HI-MILL MANUFACTURING COMPANY
FINAL TECHNICAL MEMORANDUM

Revision #3
Master Copy

June 1991

Below are comments concerning the Hi-Mill Manufacturing Draft Technical Memorandum from Karla Johnson of the USEPA (#1-#10), Murat Akyurek of Donohue & Associates (#11-#21) and Deborah Larson of the MDNR (22-#26). Each comment/concern from the agency is followed by a corresponding response from Geraghty & Miller, Inc.

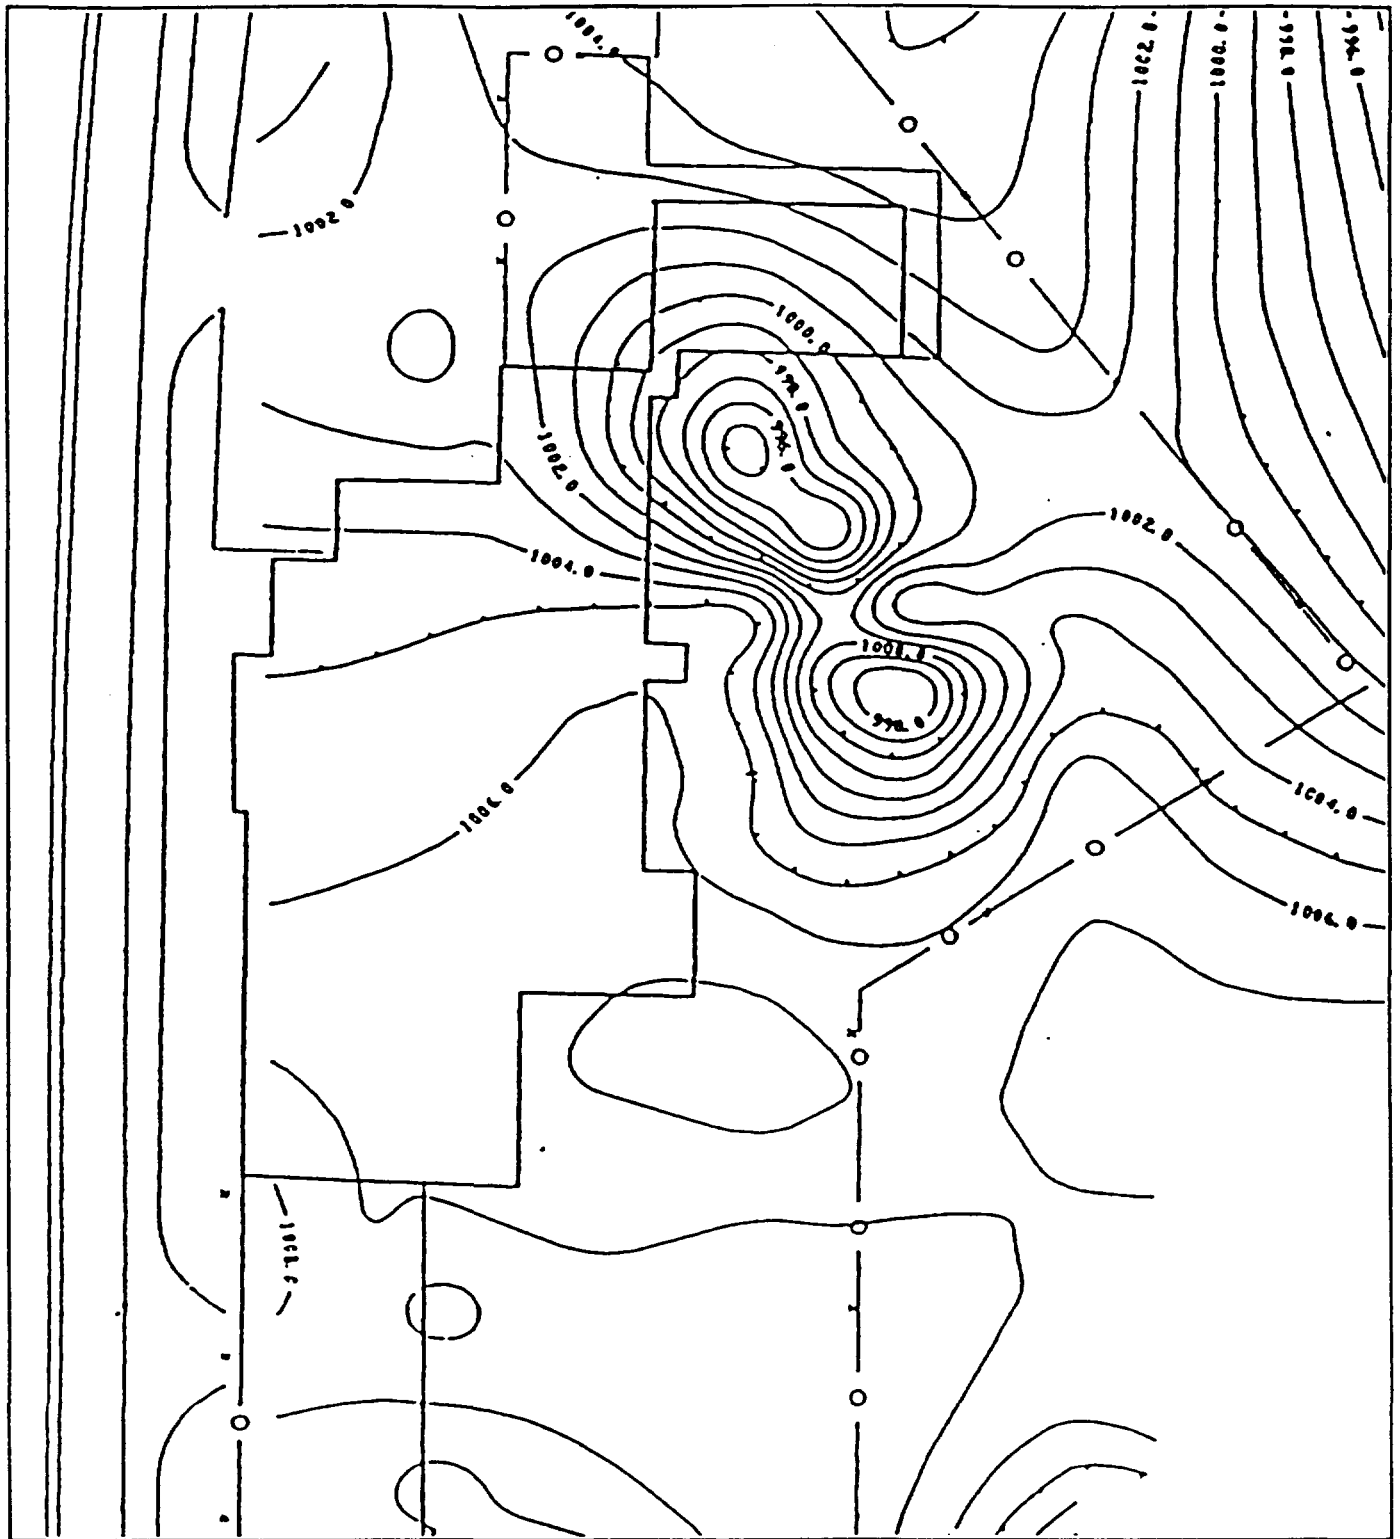
- 19b C: Figure 17 has no scale, north arrow, or legend. This makes it difficult to concur with this paragraph.
- R: A "north" arrow has been added to Figure 17.

FIGURE 18
INTERMEDIATE WELLS
POTENTIOMETRIC SURFACE MAP
OCTOBER 31, 1990
HIMILL MANUFACTURING
HIGHLAND MICHIGAN

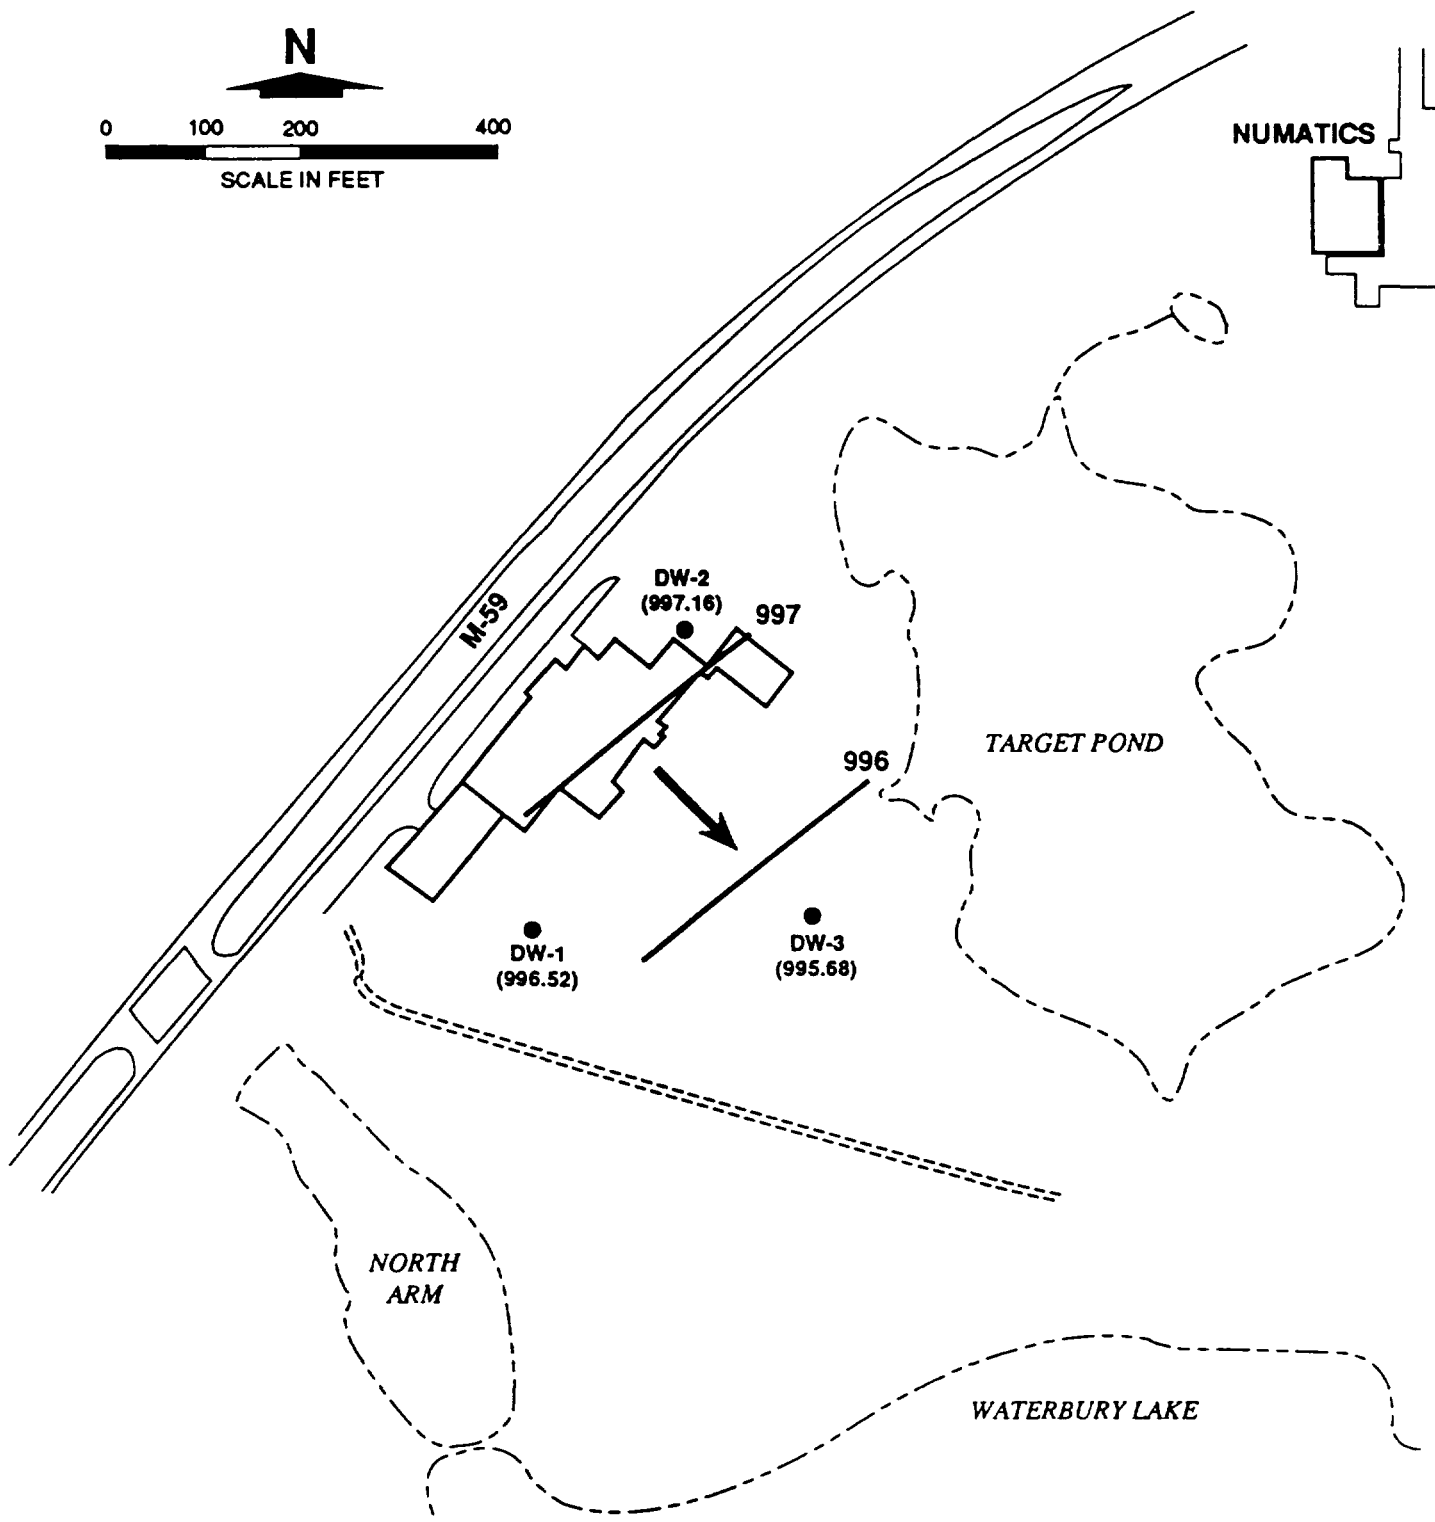
- 21 8/3 C: Figure 18 has a mislabeled legend (equipotential lines and ground-water flow direction). It is also suggested that potentiometric surface maps be relabeled to reflect the aquifer or hydrogeologic unit (i.e., Intermediate Aquifer Potentiometric Surface rather than Intermediate Wells Potentiometric Map).

- R: The mistakes in Figure 18 have been corrected.
- 22 General C: It is the opinion of Michigan Department of Natural Resources (MDNR) that all of the existing monitoring wells at and around the Hi-Mill facility should be sampled a second time. We do not feel that one round of sampling is sufficient to characterize all ground-water conditions to the extent that any wells can be eliminated at this time. We do concur that, as a result of the analytical results from round one of well sampling, more of the monitoring wells, as proposed in the tech memo, should be sampled and analyzed for volatile organic compounds than were during the first round of sampling. However, none of the metals should be eliminated from the "short list" of metals.

FIGURE 20
SOIL CLASSIFICATIONS
 HIMILL MANUFACTURING
 HIGHLAND, MICHIGAN

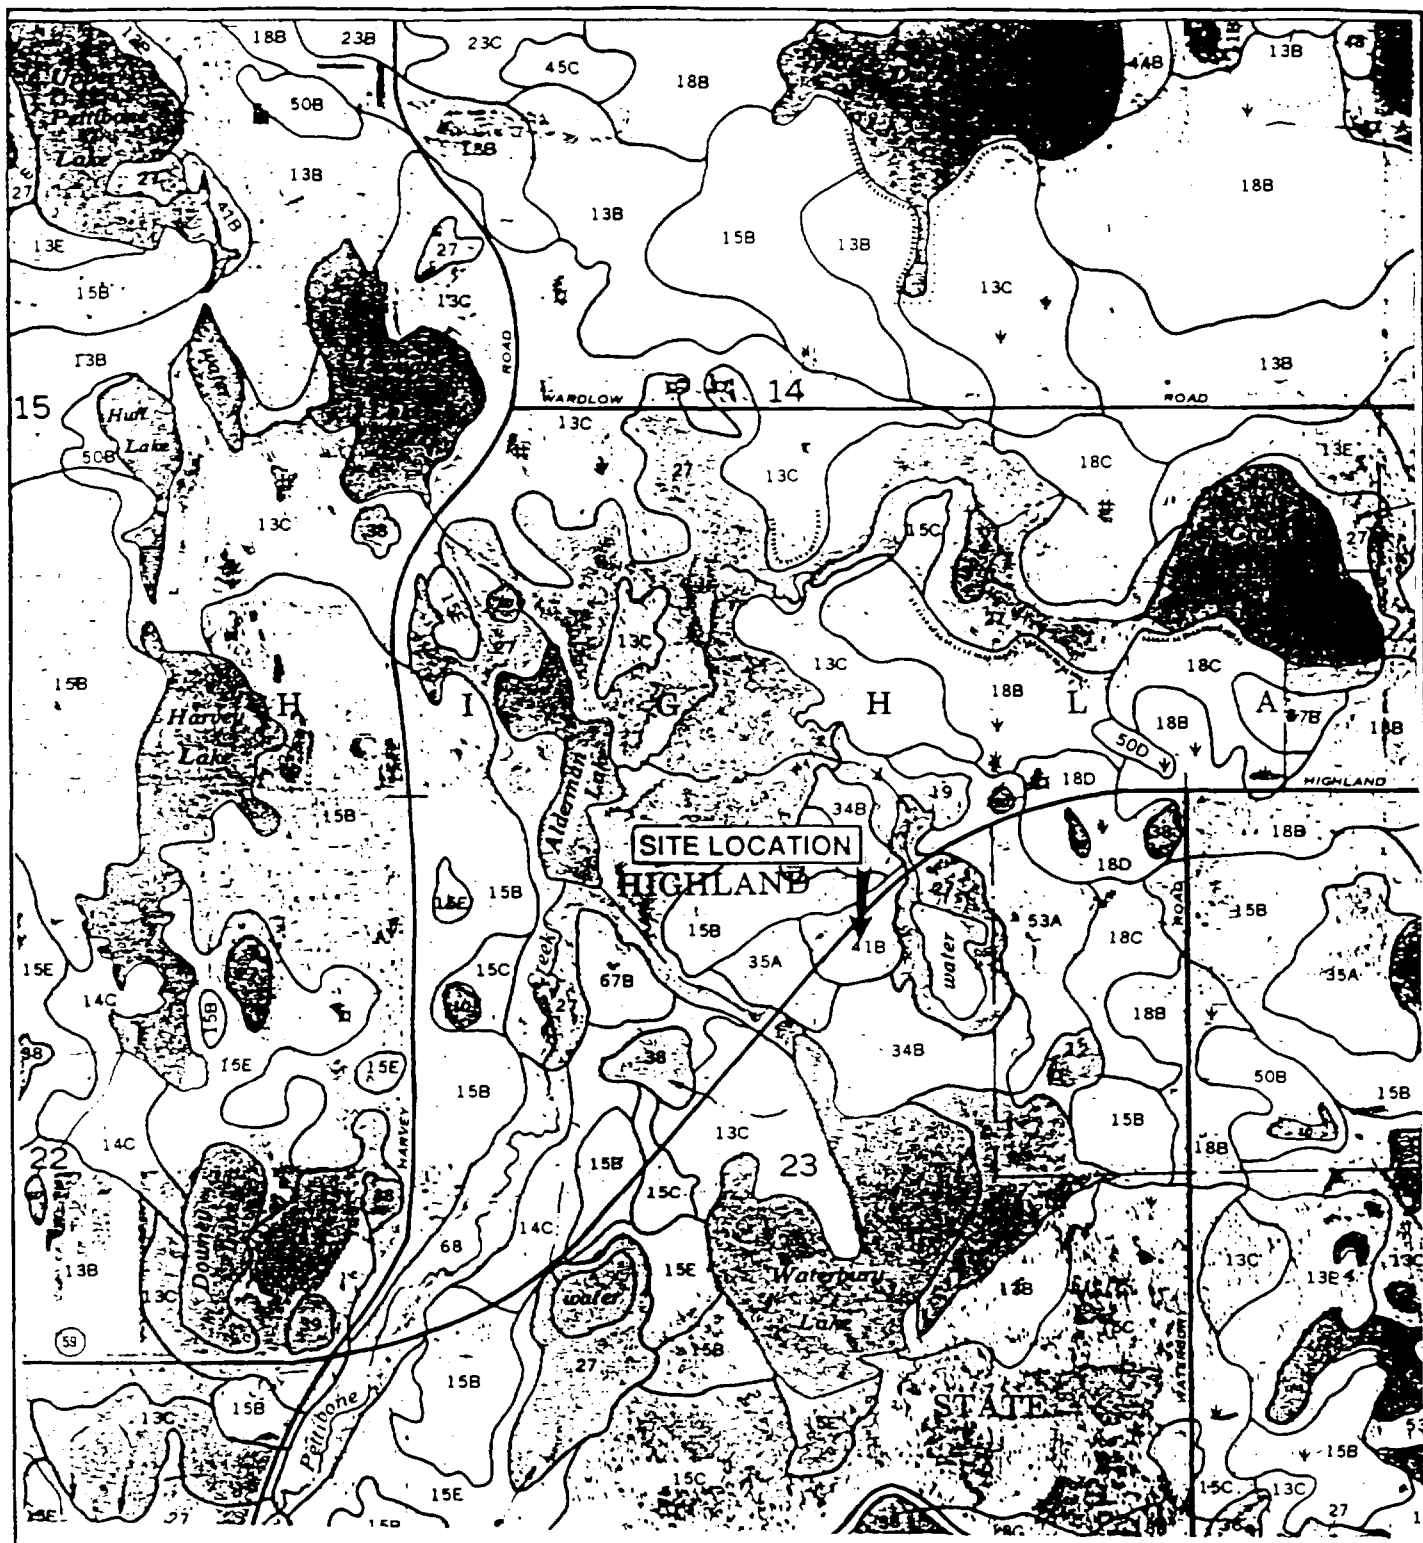
- 6c 10/3 C: Please include a legend or description for Figure 20.
- R: Legend for the figure is on the reverse side.
- 7a 11/1 C: There is a discrepancy between the chromium concentration stated in this paragraph (1620 ug/kg at 5.5 ft bsl) and that shown on Figure 23 (620 ug/kg).

FIGURE 24
CHROMIUM
ISOCONCENTRATION MAP
8 - 16.5 FEET
HIMILL MANUFACTURING
HIGHLAND MICHIGAN

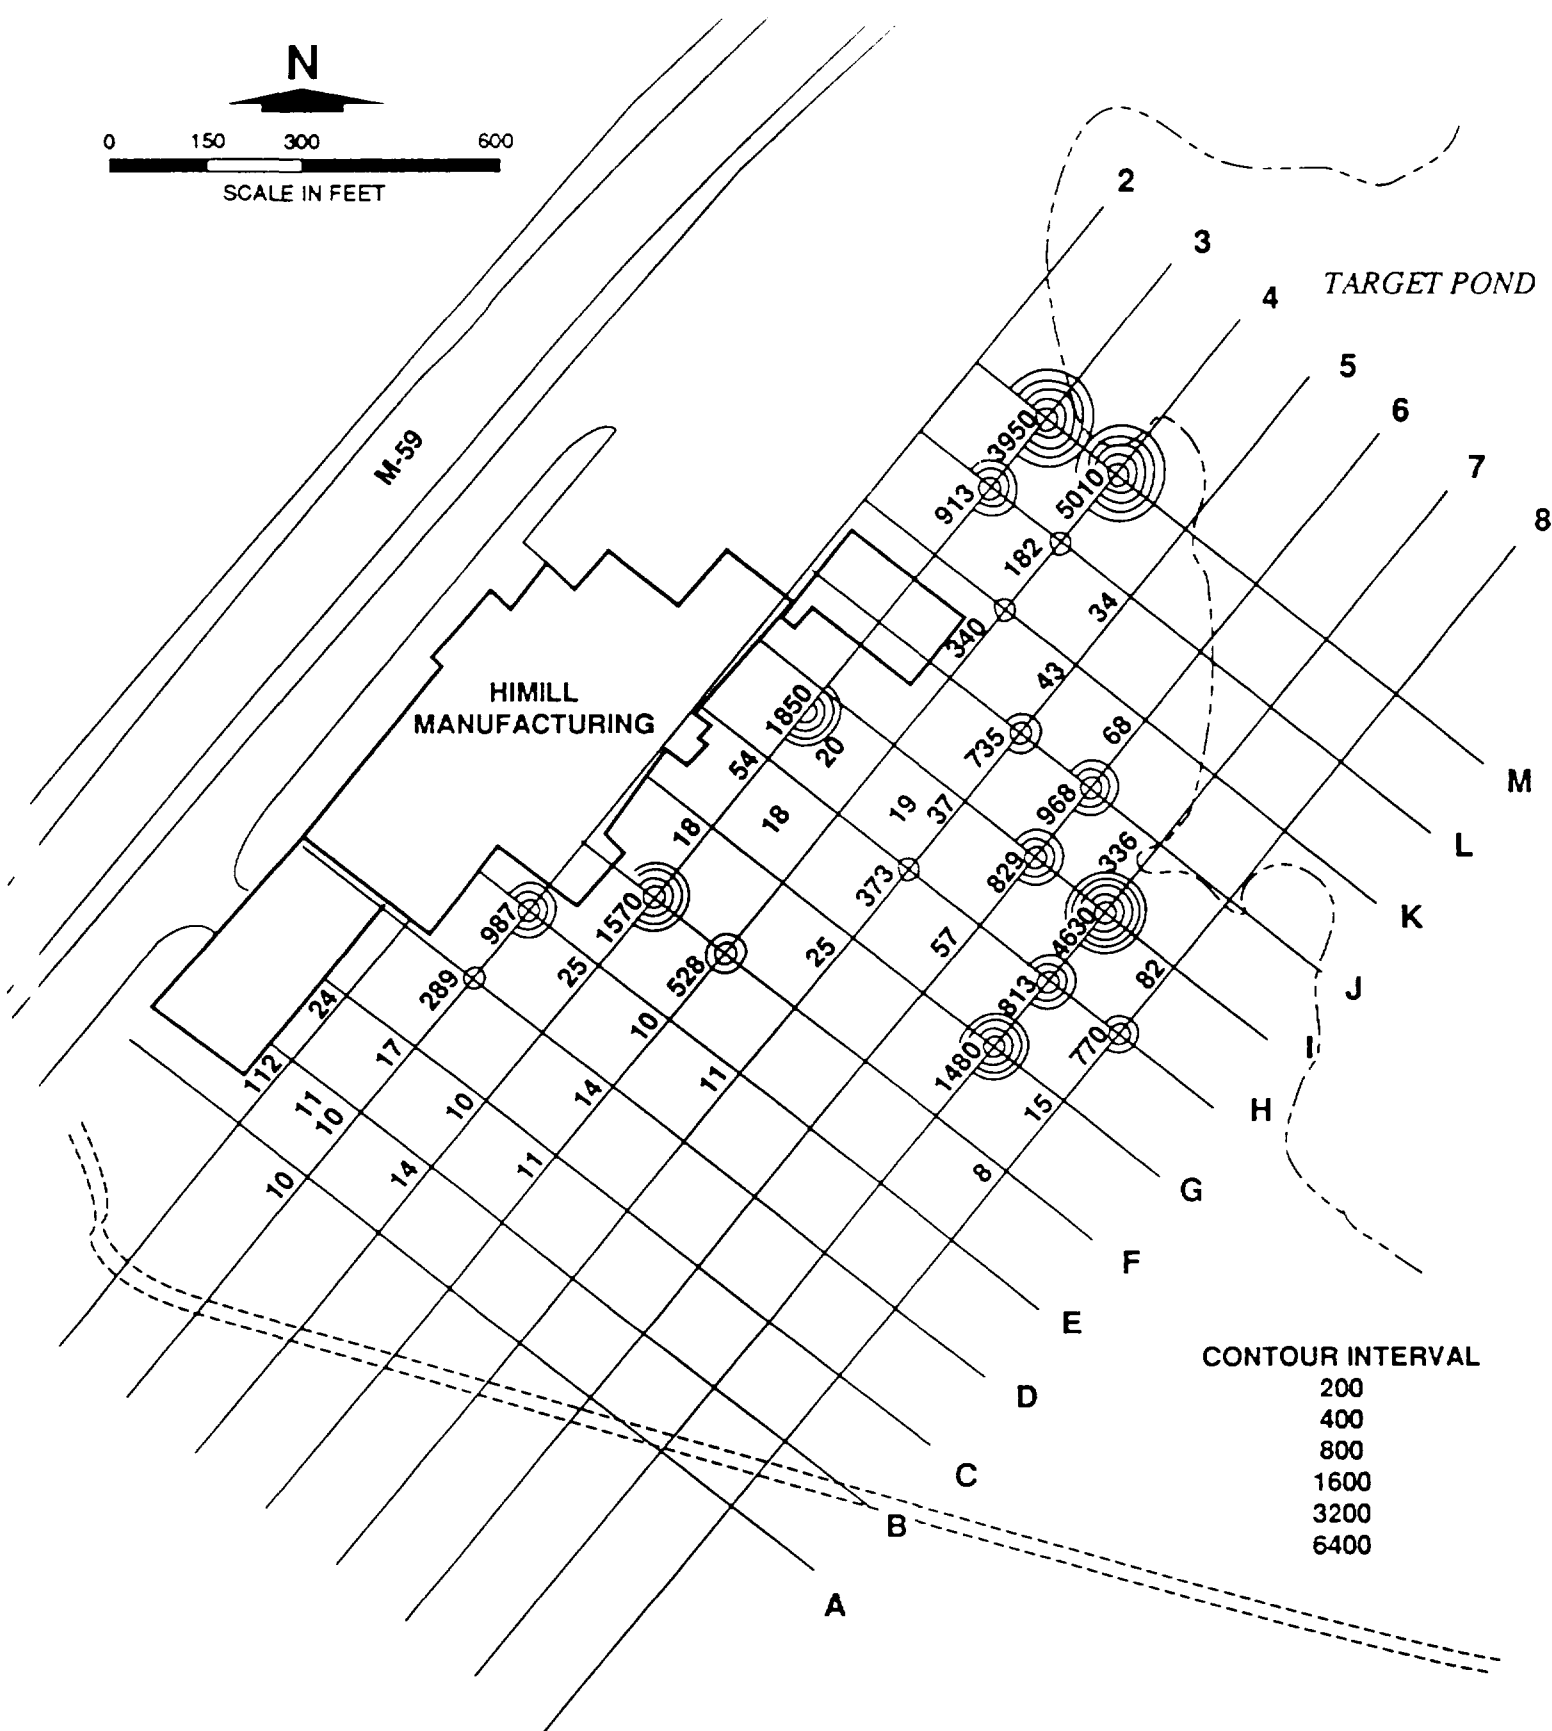
- R: Typographical error, the chromium concentration in Figure 23 was corrected to read 1620 mg/kg.
- 7b 11/1 C: Explain what the #/# chromium concentrations on Figure 24 mean.

- R: The two adjacent numbers (#/#) represent 2 samples collected at the same location within the vertical depth range given on the figure.
- 8a 11/2 C: Expand discussion on VOCs in soil.
